KAMIRA AVENUE VILLAWOOD

RFI - URBAN DESIGN REPORT

JULY 2023

**KAMIRA AVENUE
VILLAWOOD STAGE 02**

BUILDING SEPARATION NORTH SOUTH PEDESTRIAN LANE WAY

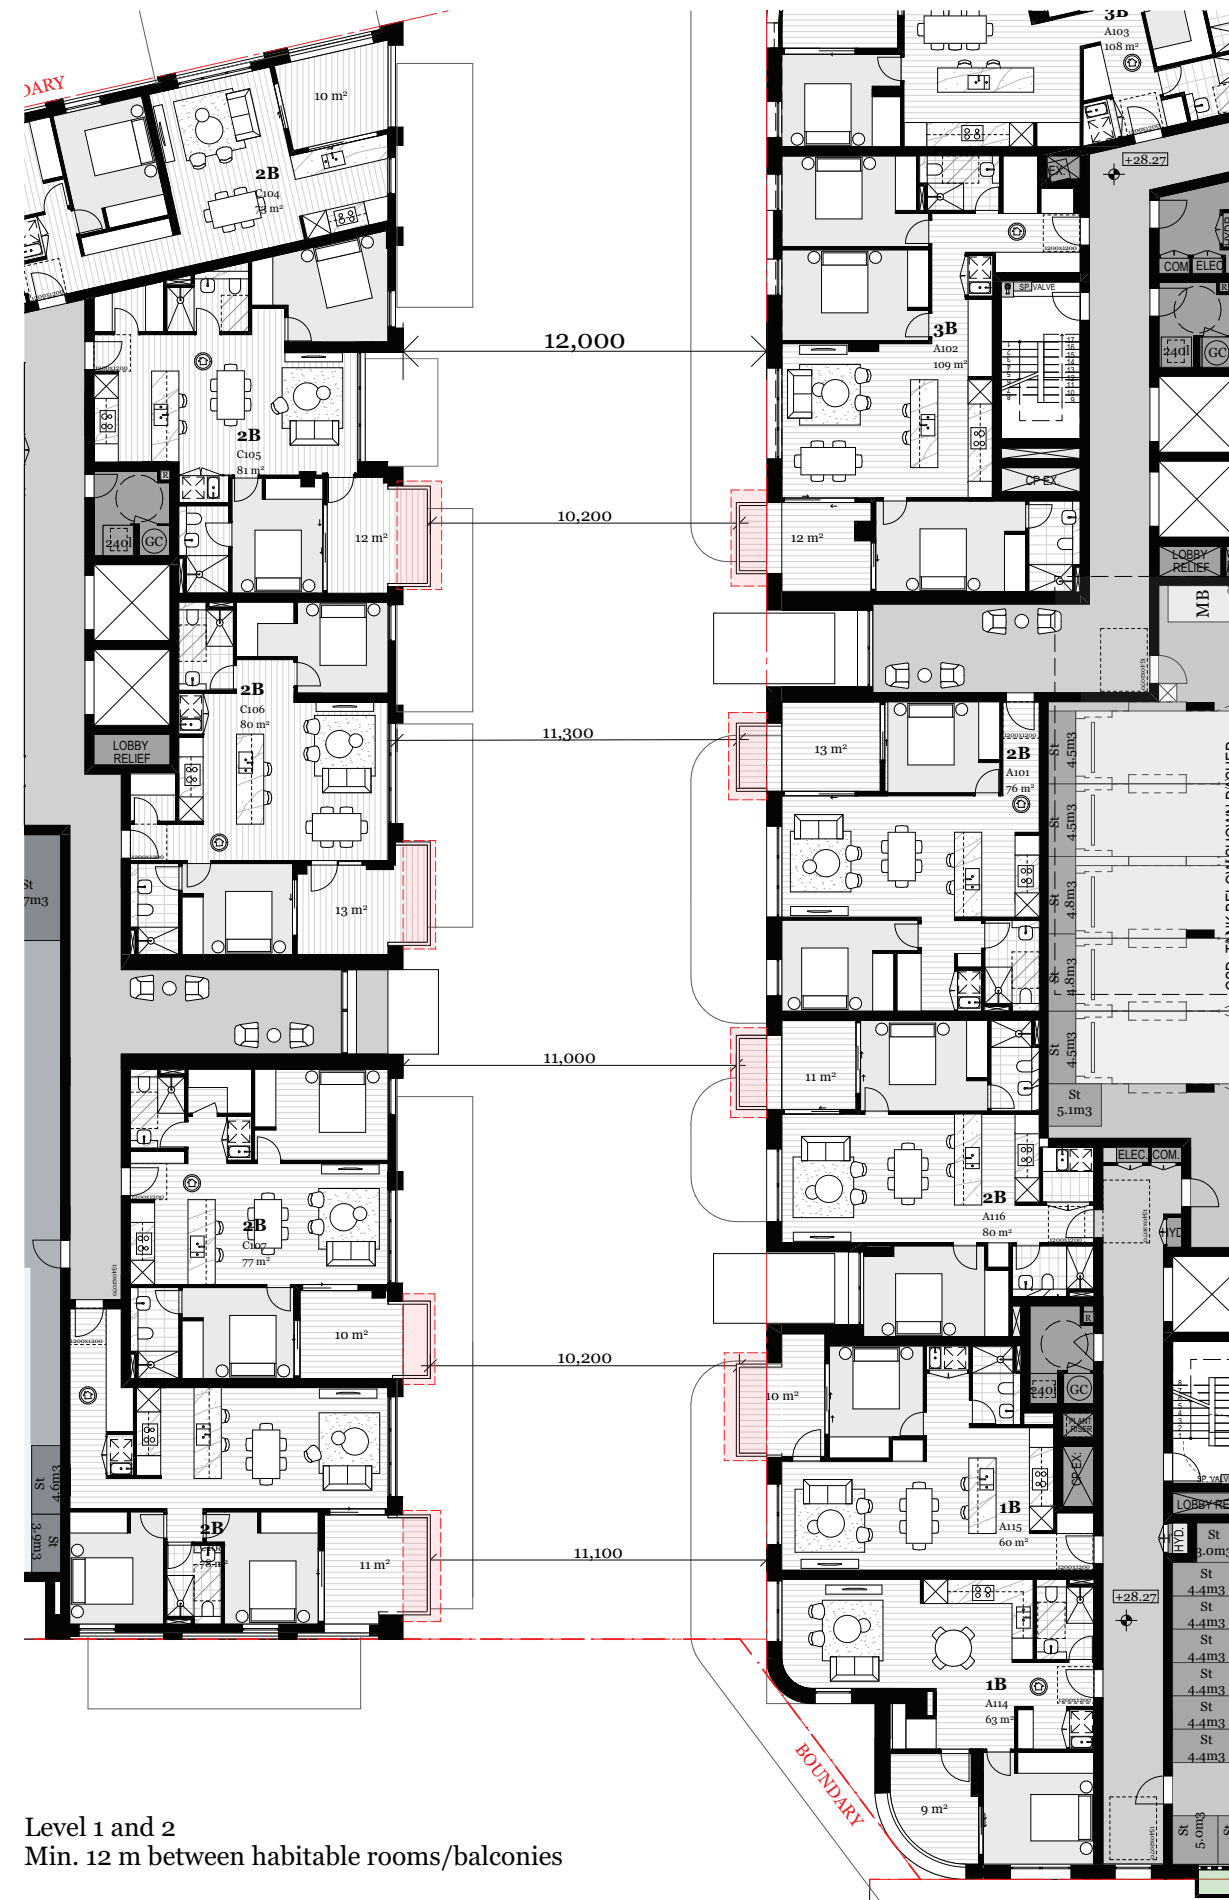
The proposed building separation distances do not comply with the ADG requirements: Across the new north-south pedestrian laneway balconies and windows for levels 1 and 2 face each other with less than the required 12 metres.

The balconies are a minor non compliance and have been staggered within the pedestrian link to minimise this non compliance. It also provides articulation and passive surveillance to the lane way. See THINK Planners covering letter for further planning context and justification.

UNIT/ ROOM SIZES AND DIMENSIONS

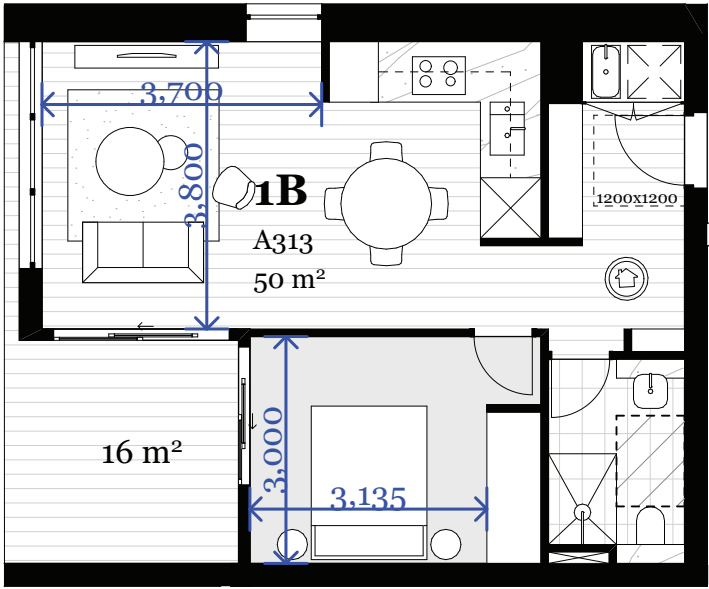
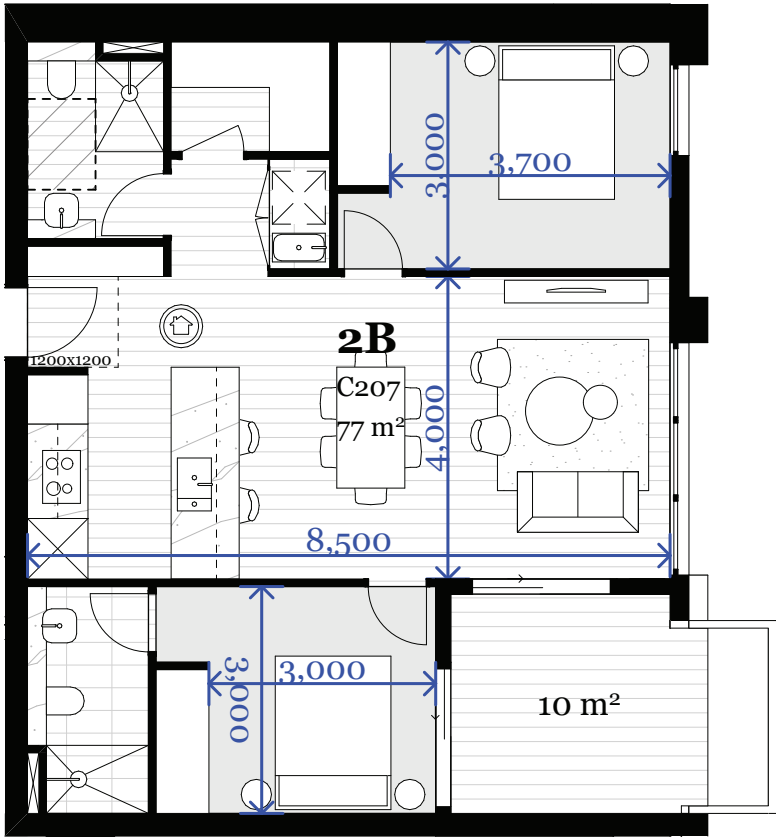
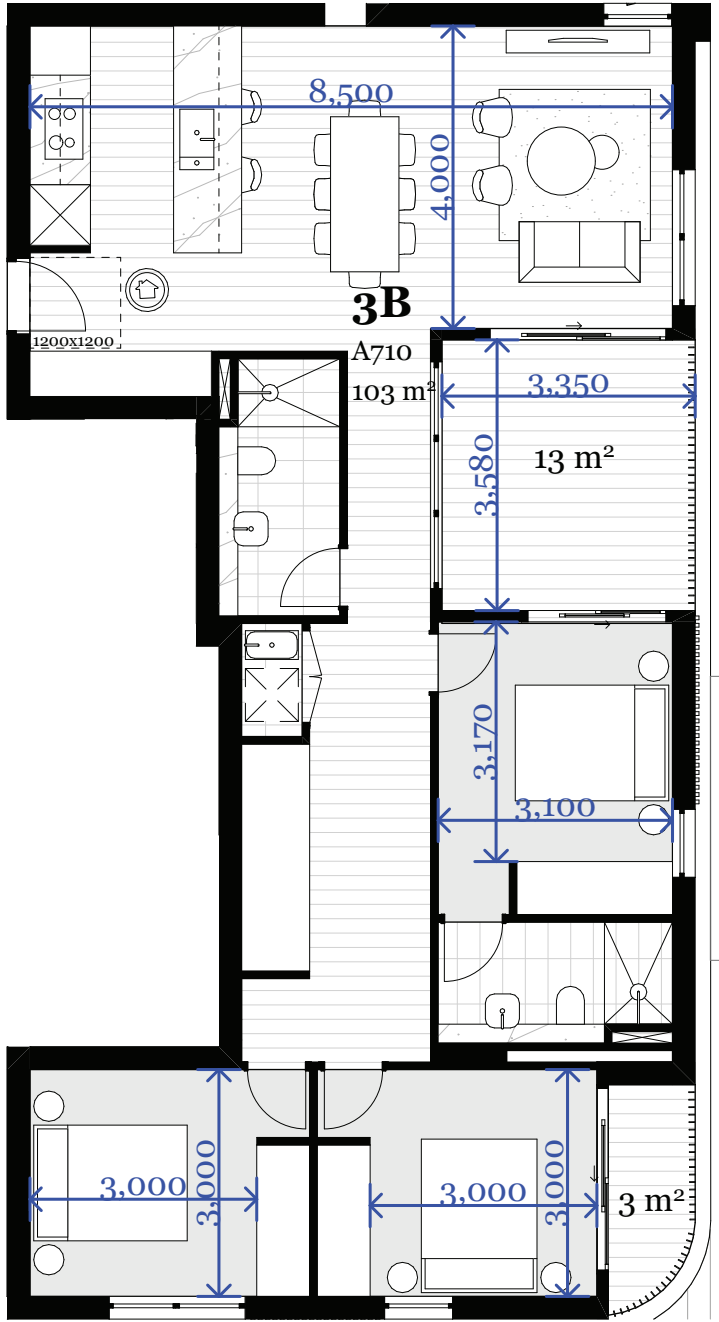
The plans shall be fully dimensioned to enable assessment of unit and room size and dimensions against the ADGs. The applicant shall ensure that all units and rooms comply with the ADGs.

Example units are provided to demonstrate the units do comply with the required minimum ADG room and unit sizes.

These apartments are the most common and typical layouts of both building stacks to demonstrate this compliance.

SOLAR ACCESS AMENDED UNIT LAYOUTS

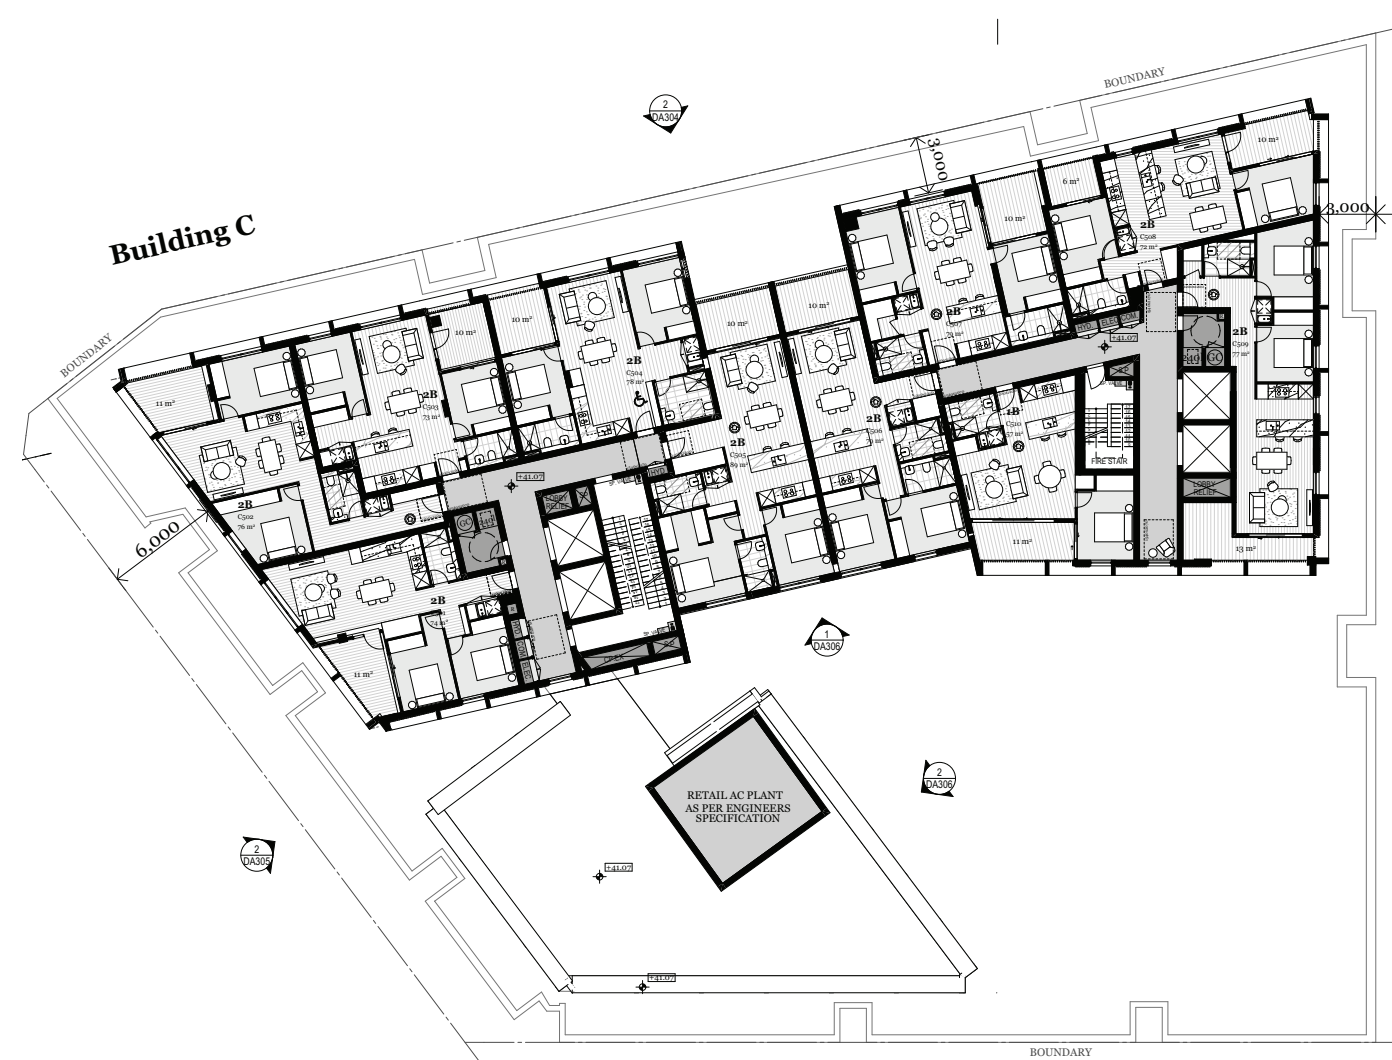
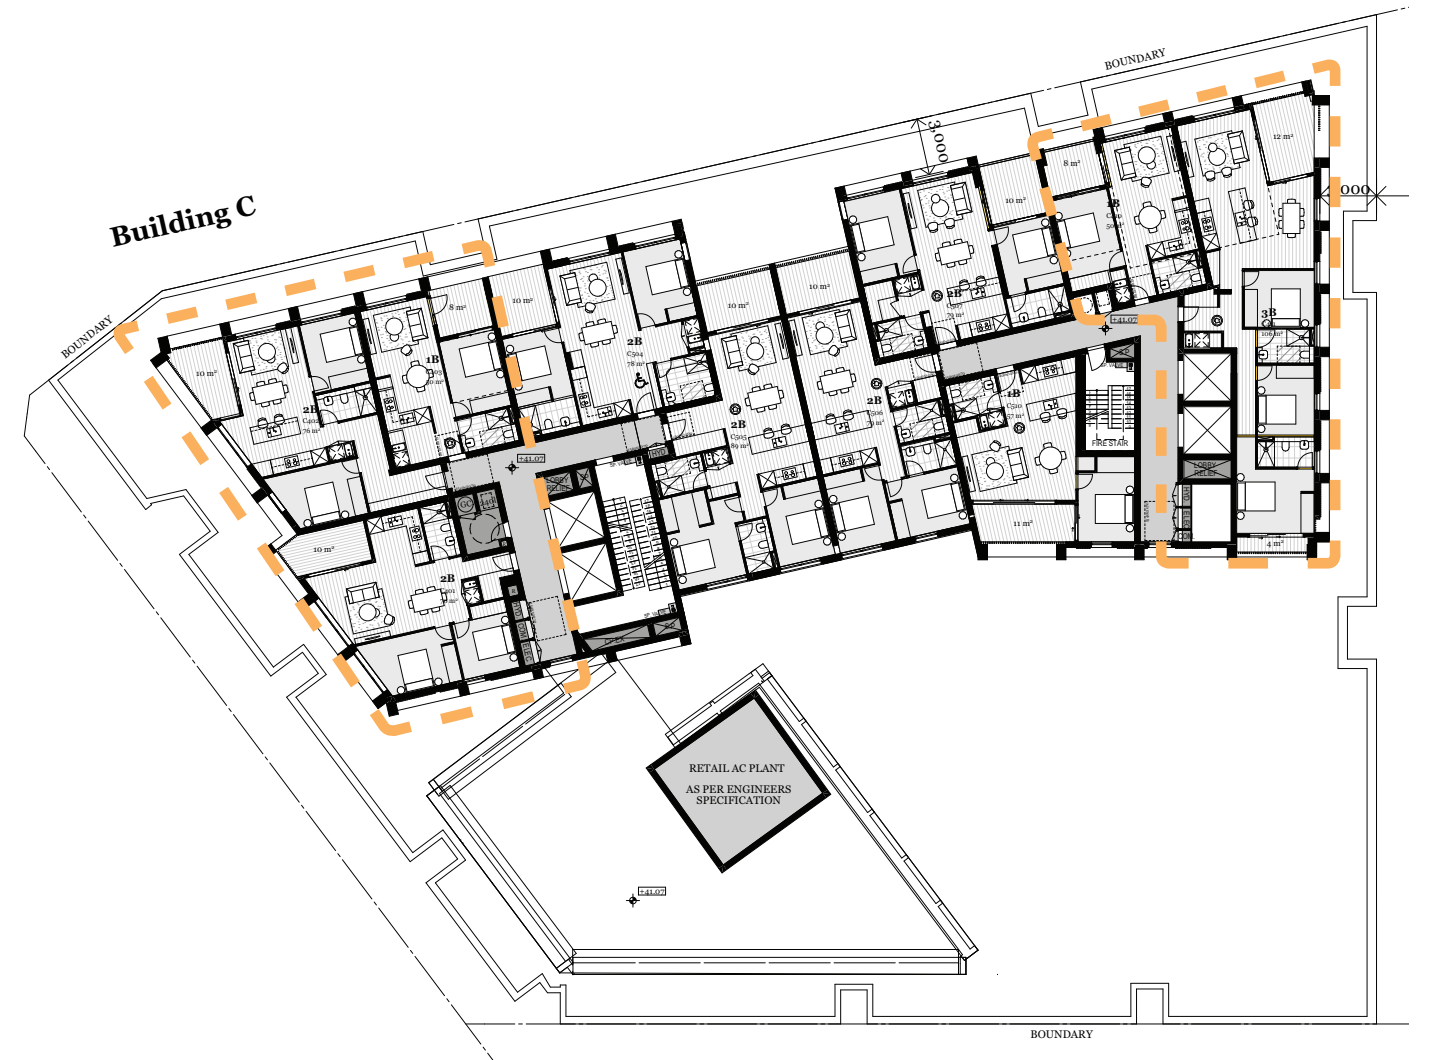
Solar access requires further review and clarification as some units are restricted by location, penetration size and balcony depths.

The highlighted plans are updated floor plans to achieve the required 2 hours of solar access to both the POS and living areas in accordance with ADG guidelines.

AWNING

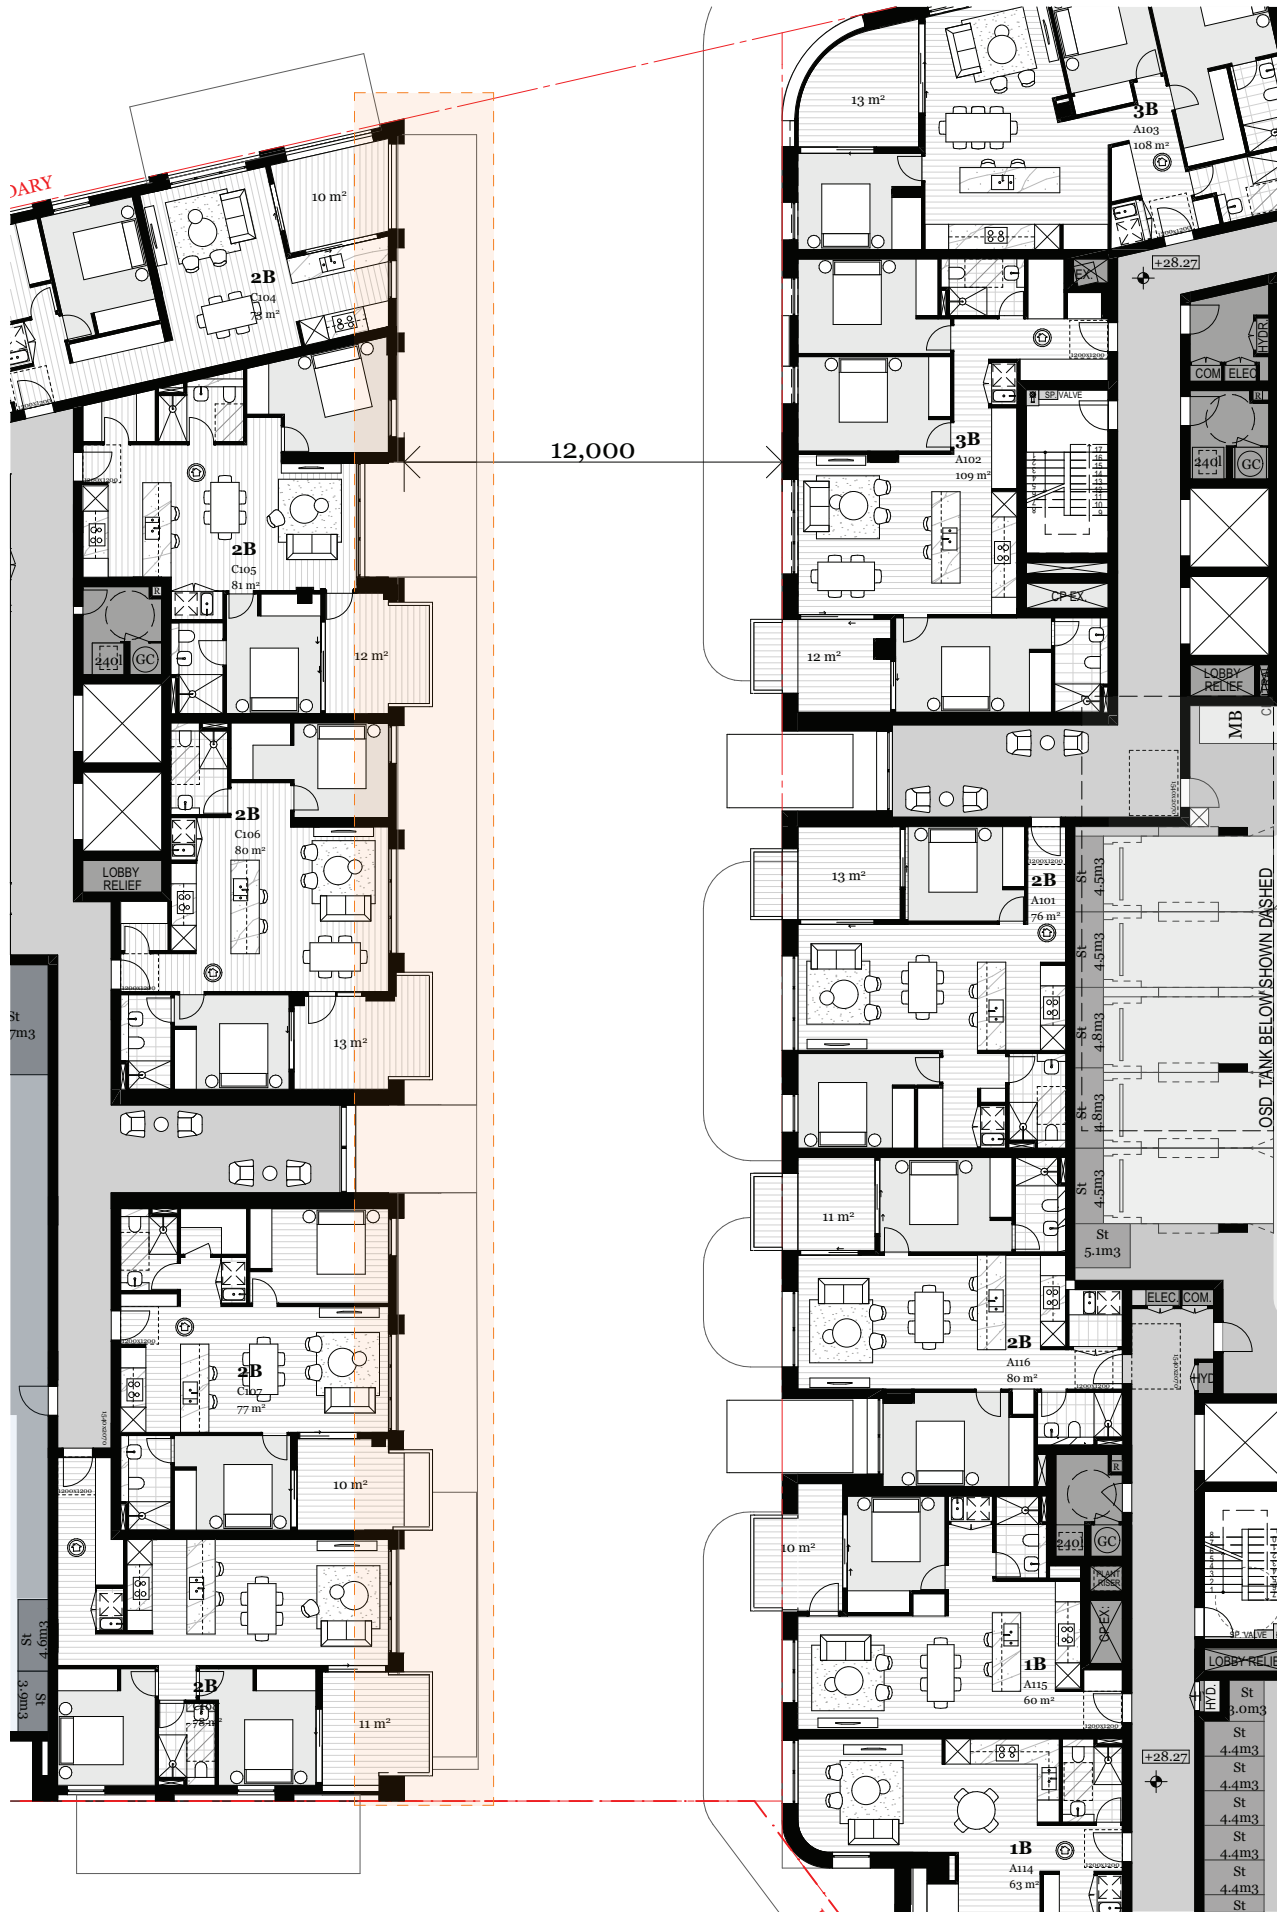
The awning over the ground floor retail areas should provide at least one side of the pedestrian areas with consistent rain protected access through the site. The current awning arrangement appears to be broken and may not have a sufficient width to provide adequate weather protection. Accordingly, a continuous awning path shall be provided and the height to width ratios need to be checked against rain and human scale.

A continuous Awning has been provided on one side within Building C.

The awning expression throughout the podium building is a way finding strategy. All the retail awnings are contained within the white portal frame.

These awnings are 2500mm wide which provide enough cover against rain

The residential lobbies have a different awning expression which induces a break in the continuous awning, but provides a feature entry piece which assists in way finding and the hierarchy of entries to the building. Further clarification is provided in the THINK Planners covering letter.
